1. SUBMITTAL TYPE: (Is this a resubmittal? Yes ☐ No ☒)			
Deferred Submittal ☐	Addendum Number: 01	Revision Number:	CCD Number: Category A ☐ or B ☐
2. PROJECT INFORMATION:			
School District/Owner: San Beranrdo City USD		DSA File Number: 36 H7	
Project Name/School: Indian Springs HS - Health Center		DSA Application Number 04 123900

ADDENDUM NO. 1

Indian Springs High School – Health Center

DSA #04-123900 FILE #36-H7 RCA Project No. 1-78-50

W215-0 SCALE: NO SCALE **HOLDOWN ANCHORS** 6

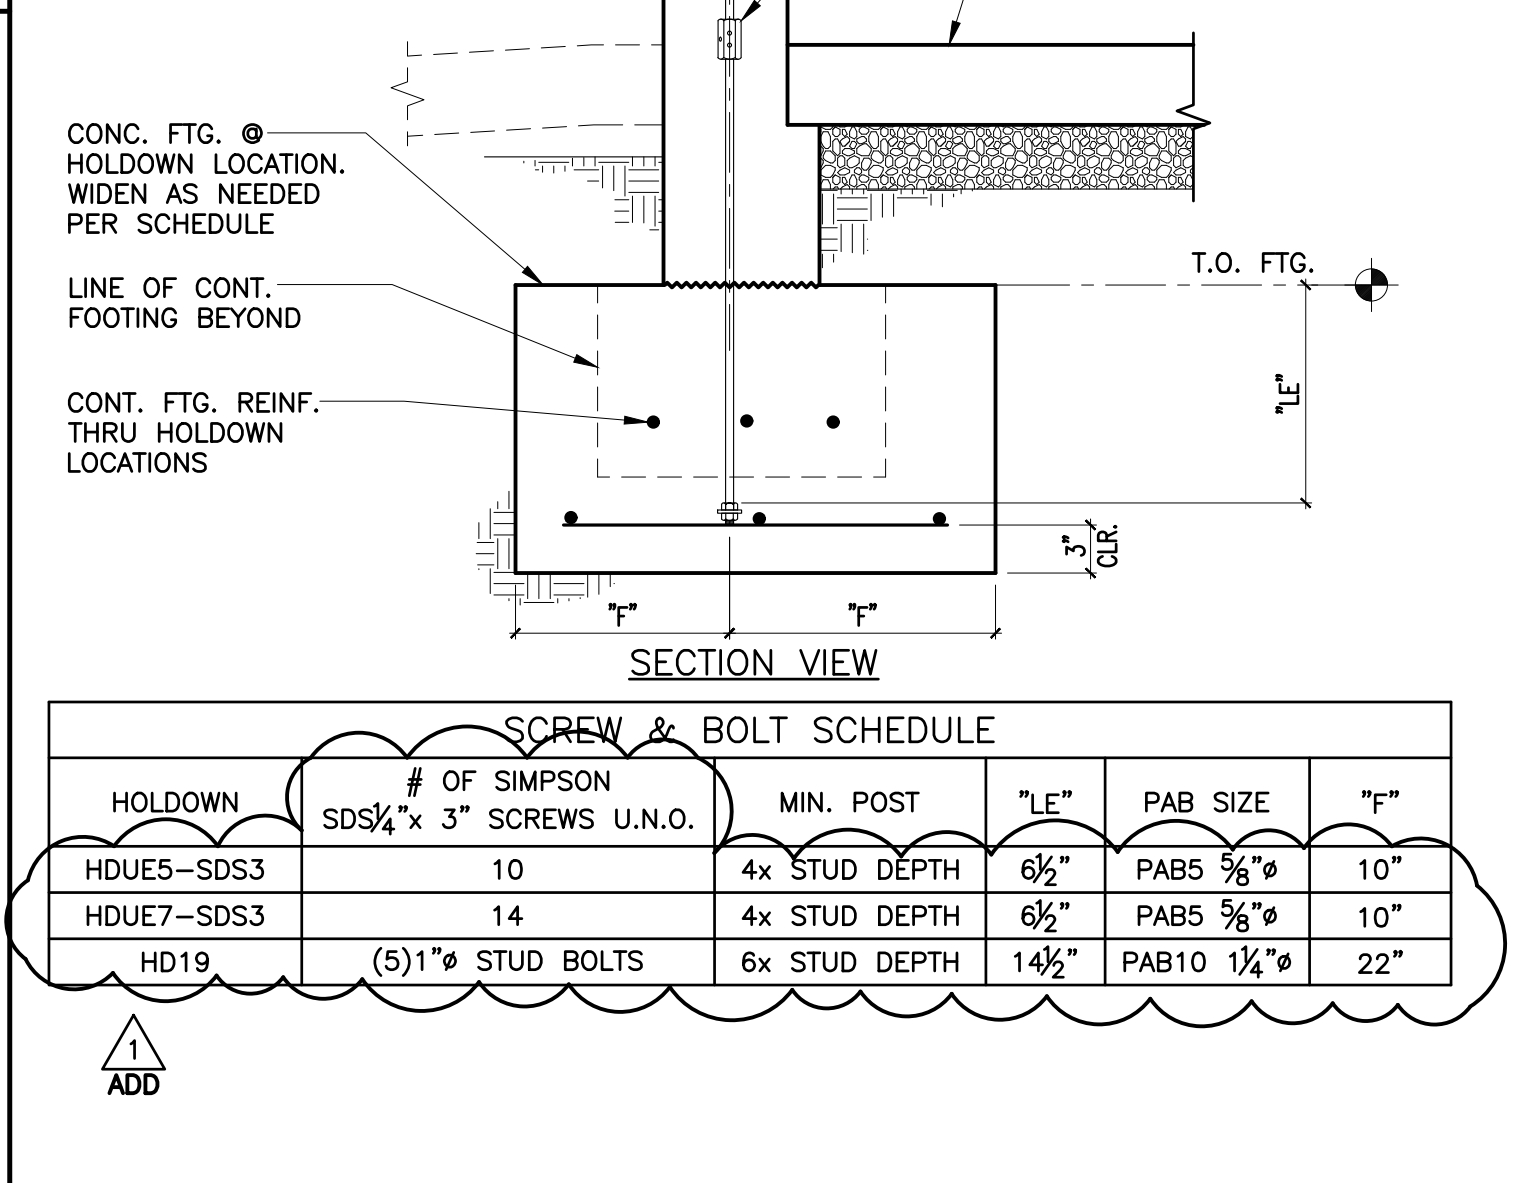
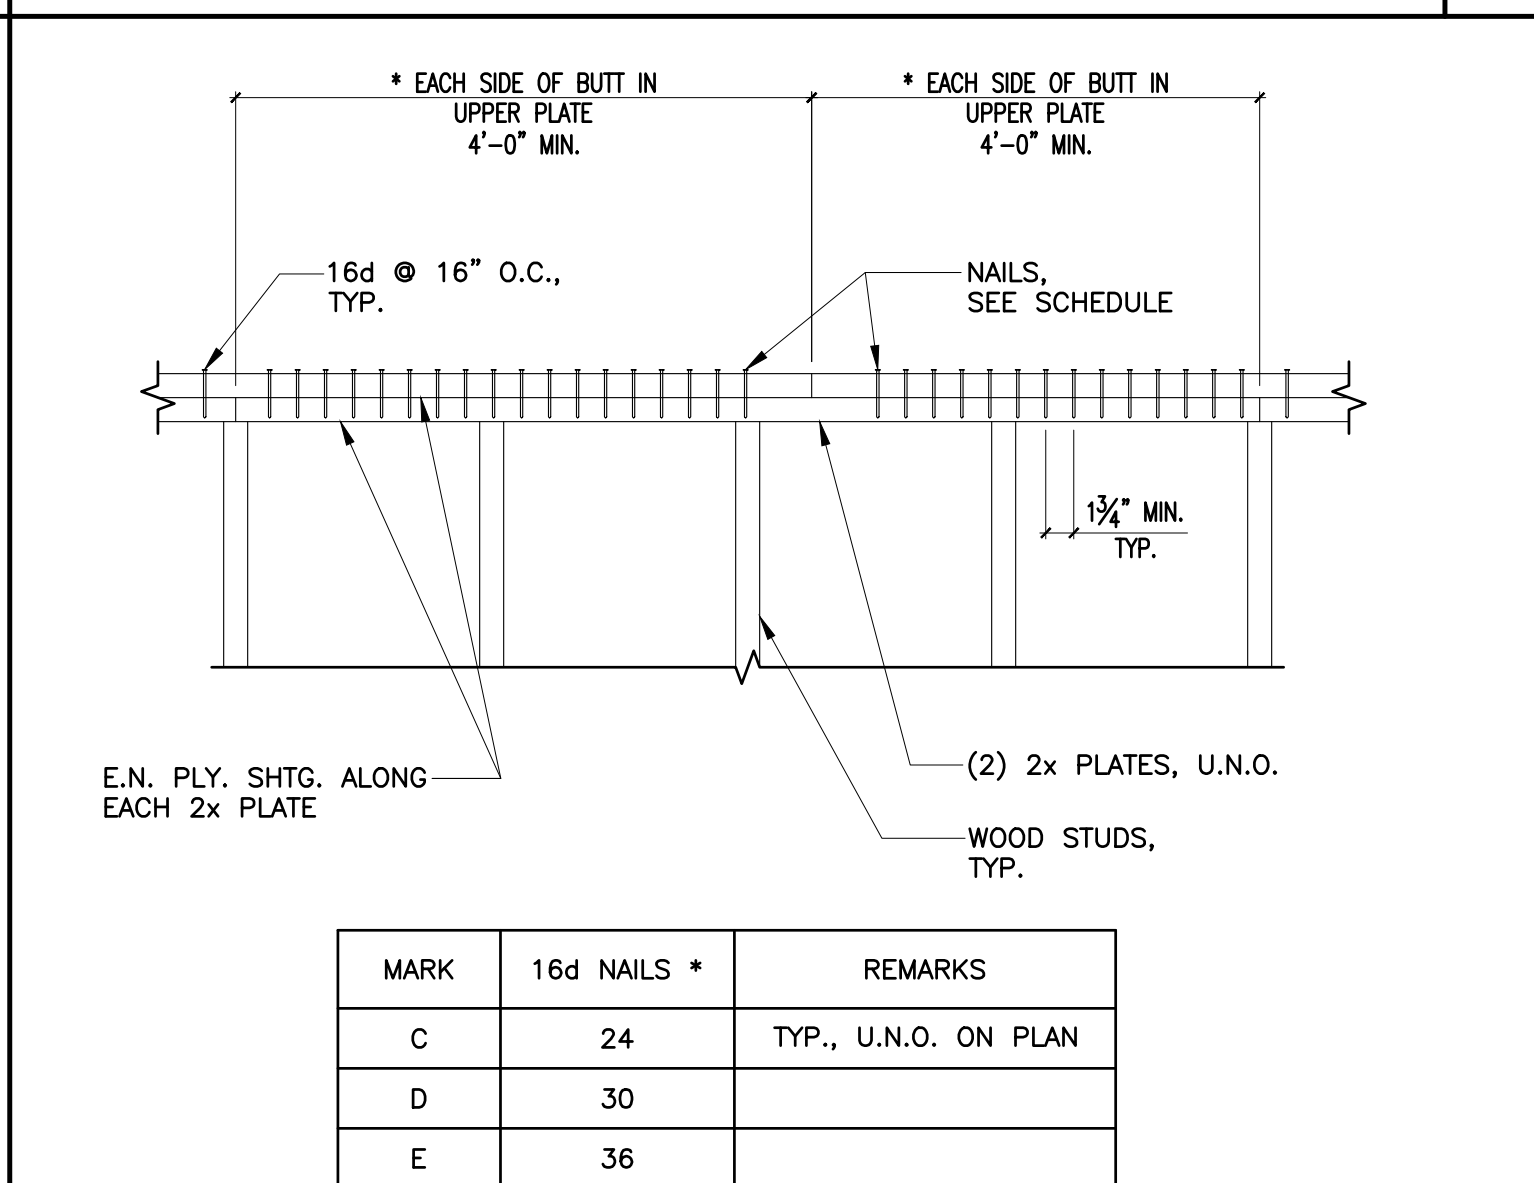
- Item No. 1.22 Reference Sheet S0-2.4 - TYPICAL WOOD DETAILS
- 1.22.1 Replace Sheet S0-2.4 and revise per clouded areas & items listed below:
- (a) Detail 6, revise Holdown Anchor Schedule

FOUNDATION PLAN NOTES

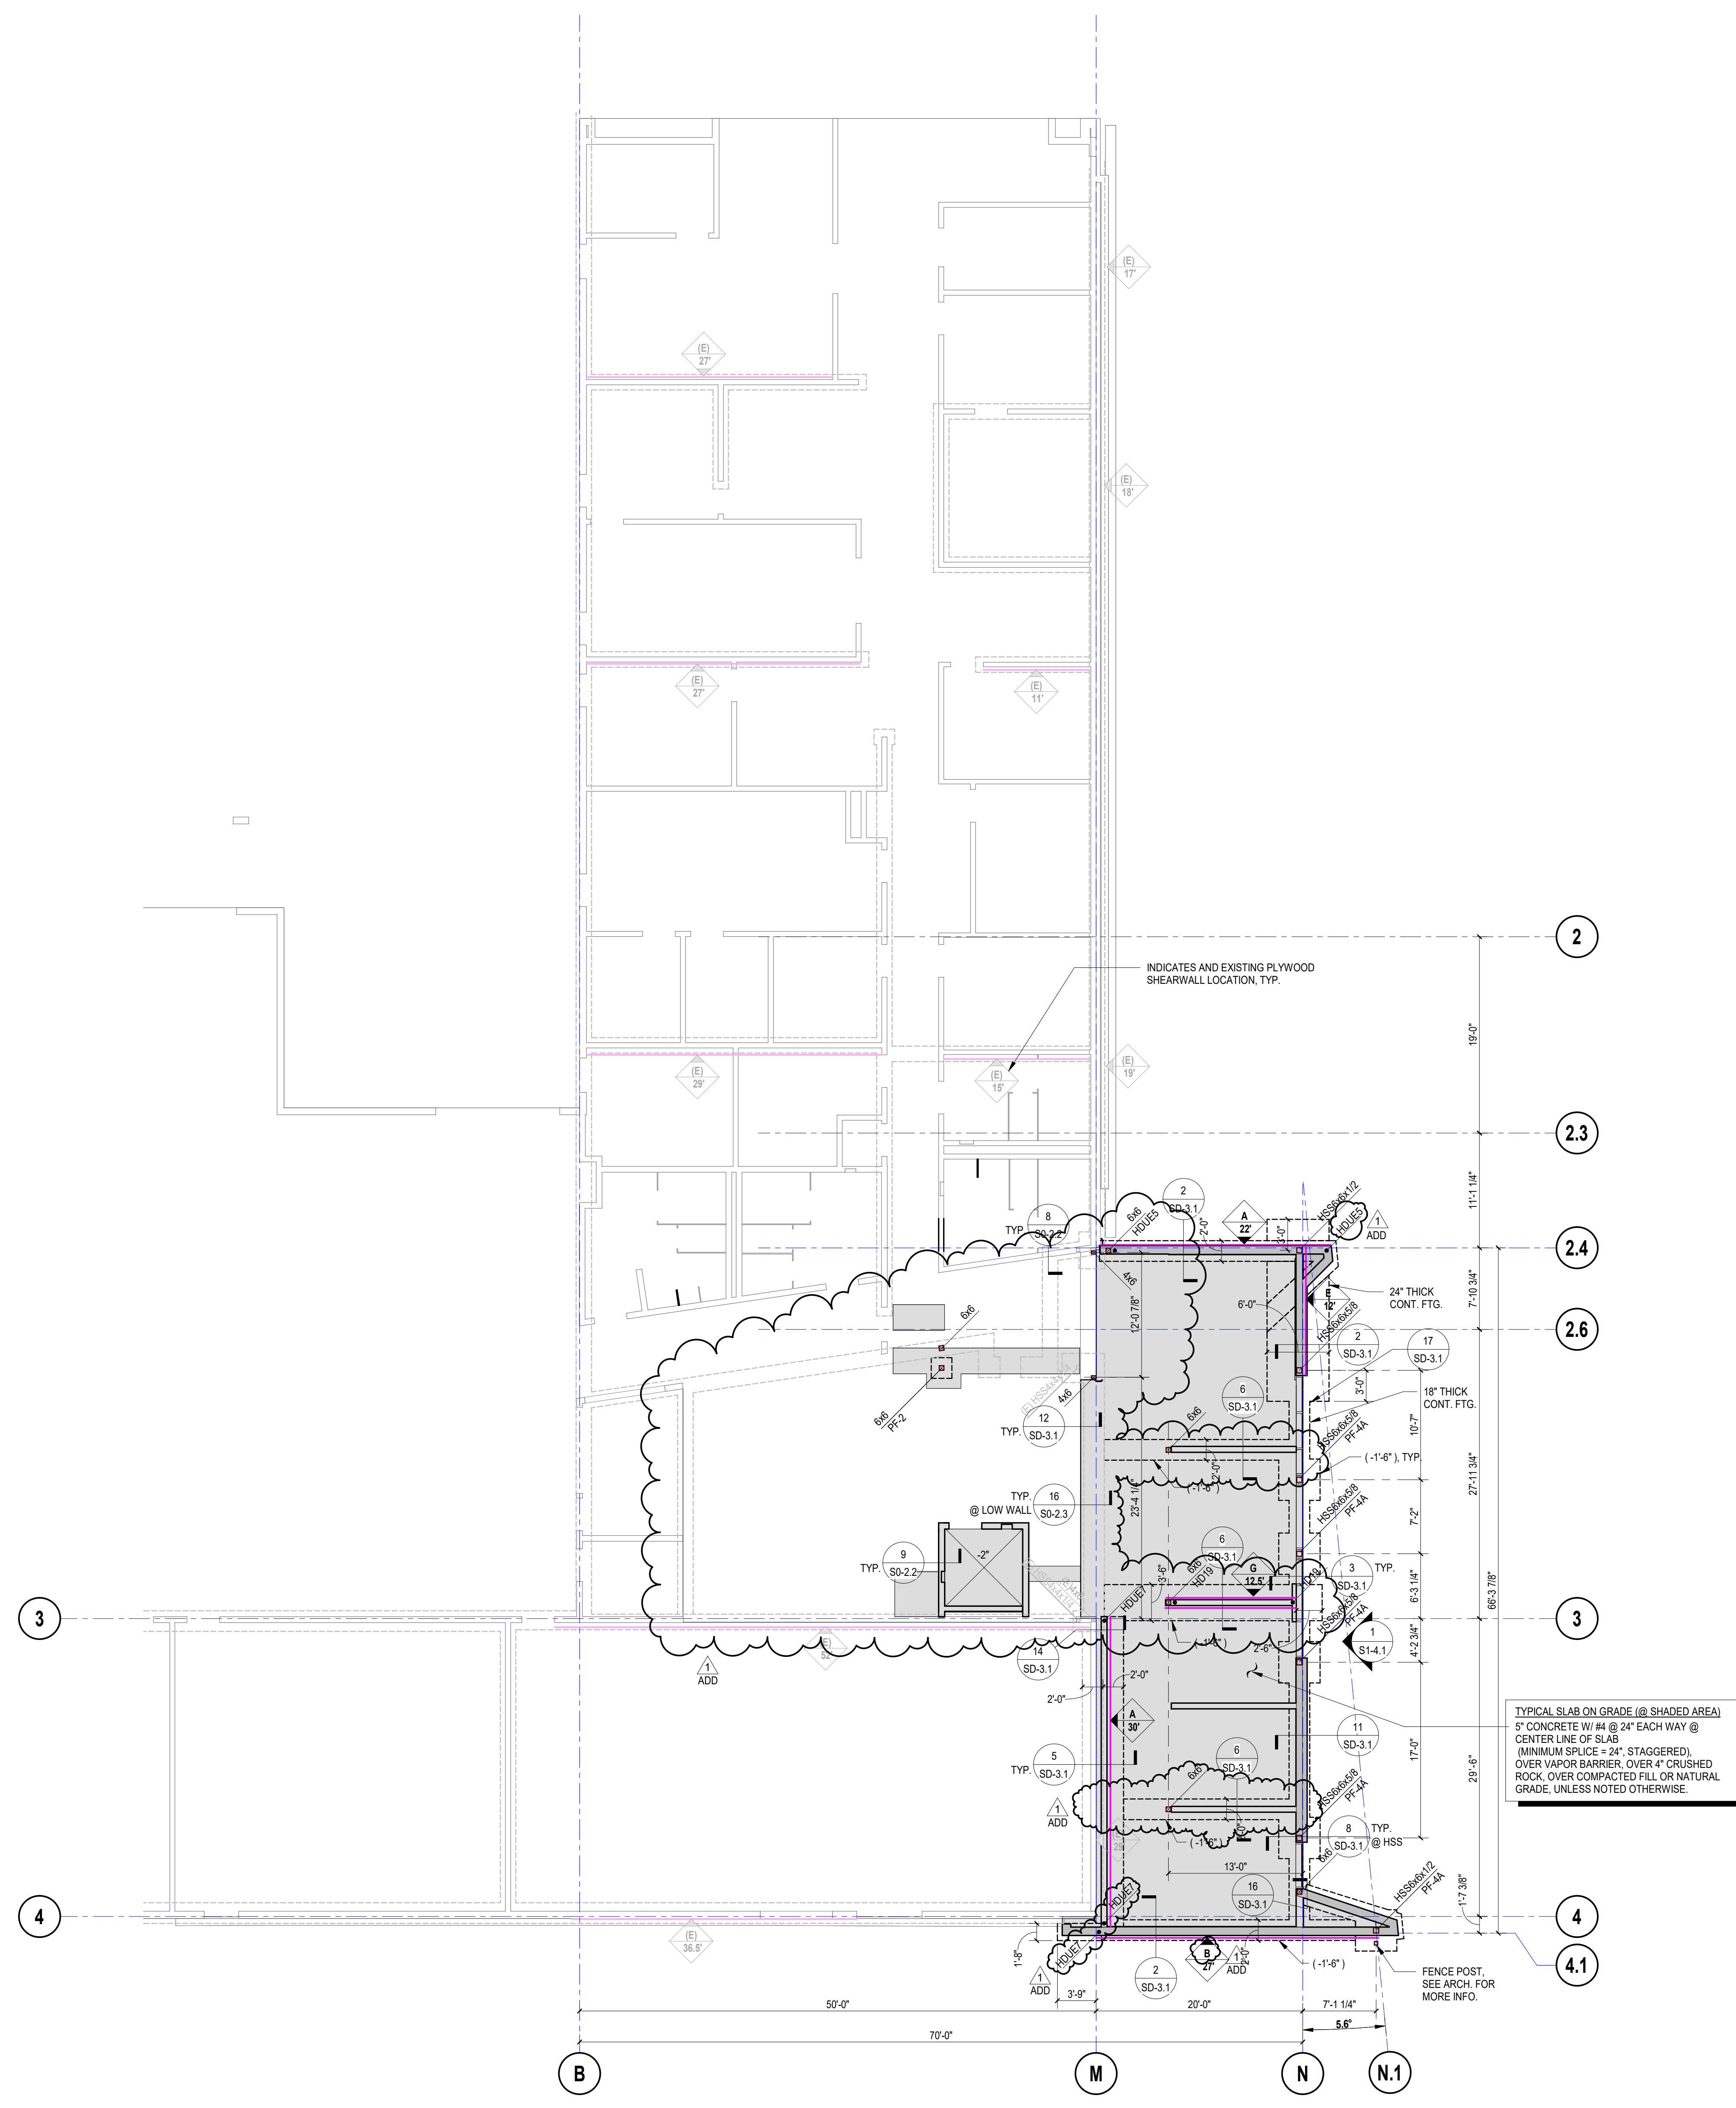
- Item No. 1.23 Reference Sheet S1-1.1 - FOUNDATION PLAN
- 1.23.1 Replace Sheet S1-1.1 and revise per clouded areas & items listed below:
- (a) Revised Foundation Plan in coordination with Architectural changes

ROOF FRAMING PLAN
SCALE: 1/8" = 1'-0"

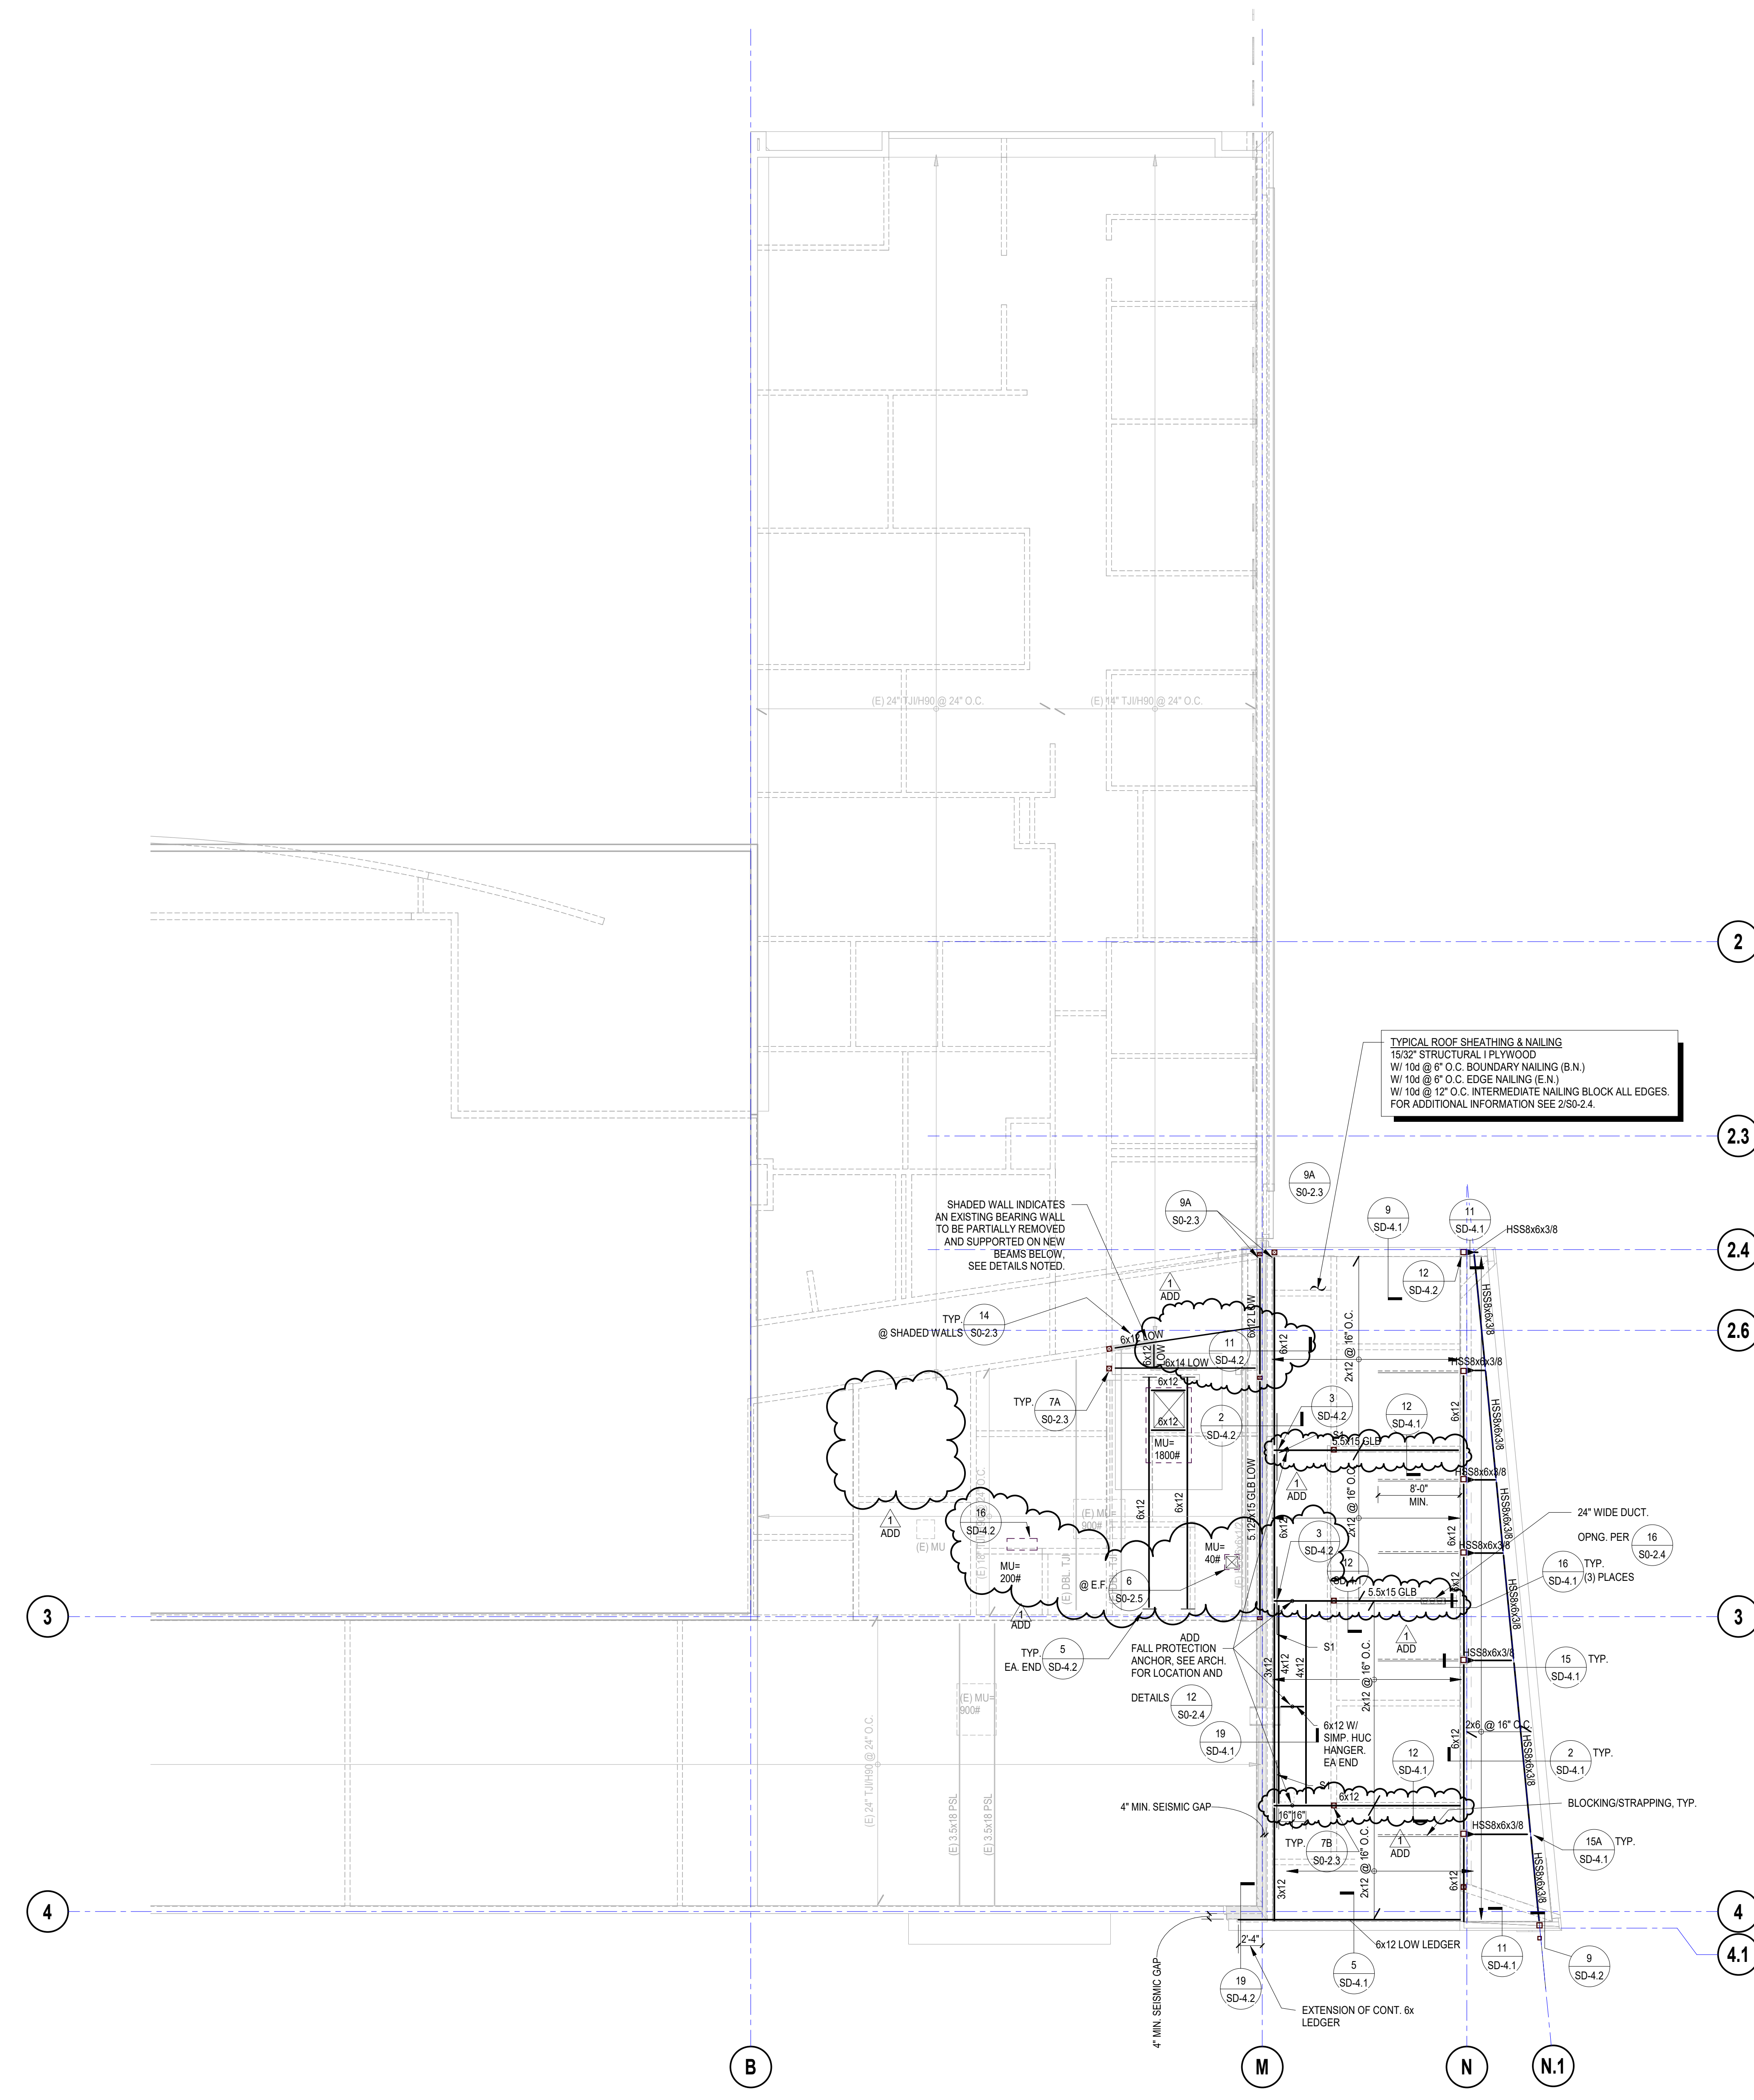
- Item No. 1.24 Reference Sheet S1-3.1 - ROOF FRAMING PLAN
- 1.24.1 Replace Sheet S1-3.1 and revise per clouded areas & items listed below:
- (a) Revised Roof Framing Plan in coordination with Architectural & MEP changes
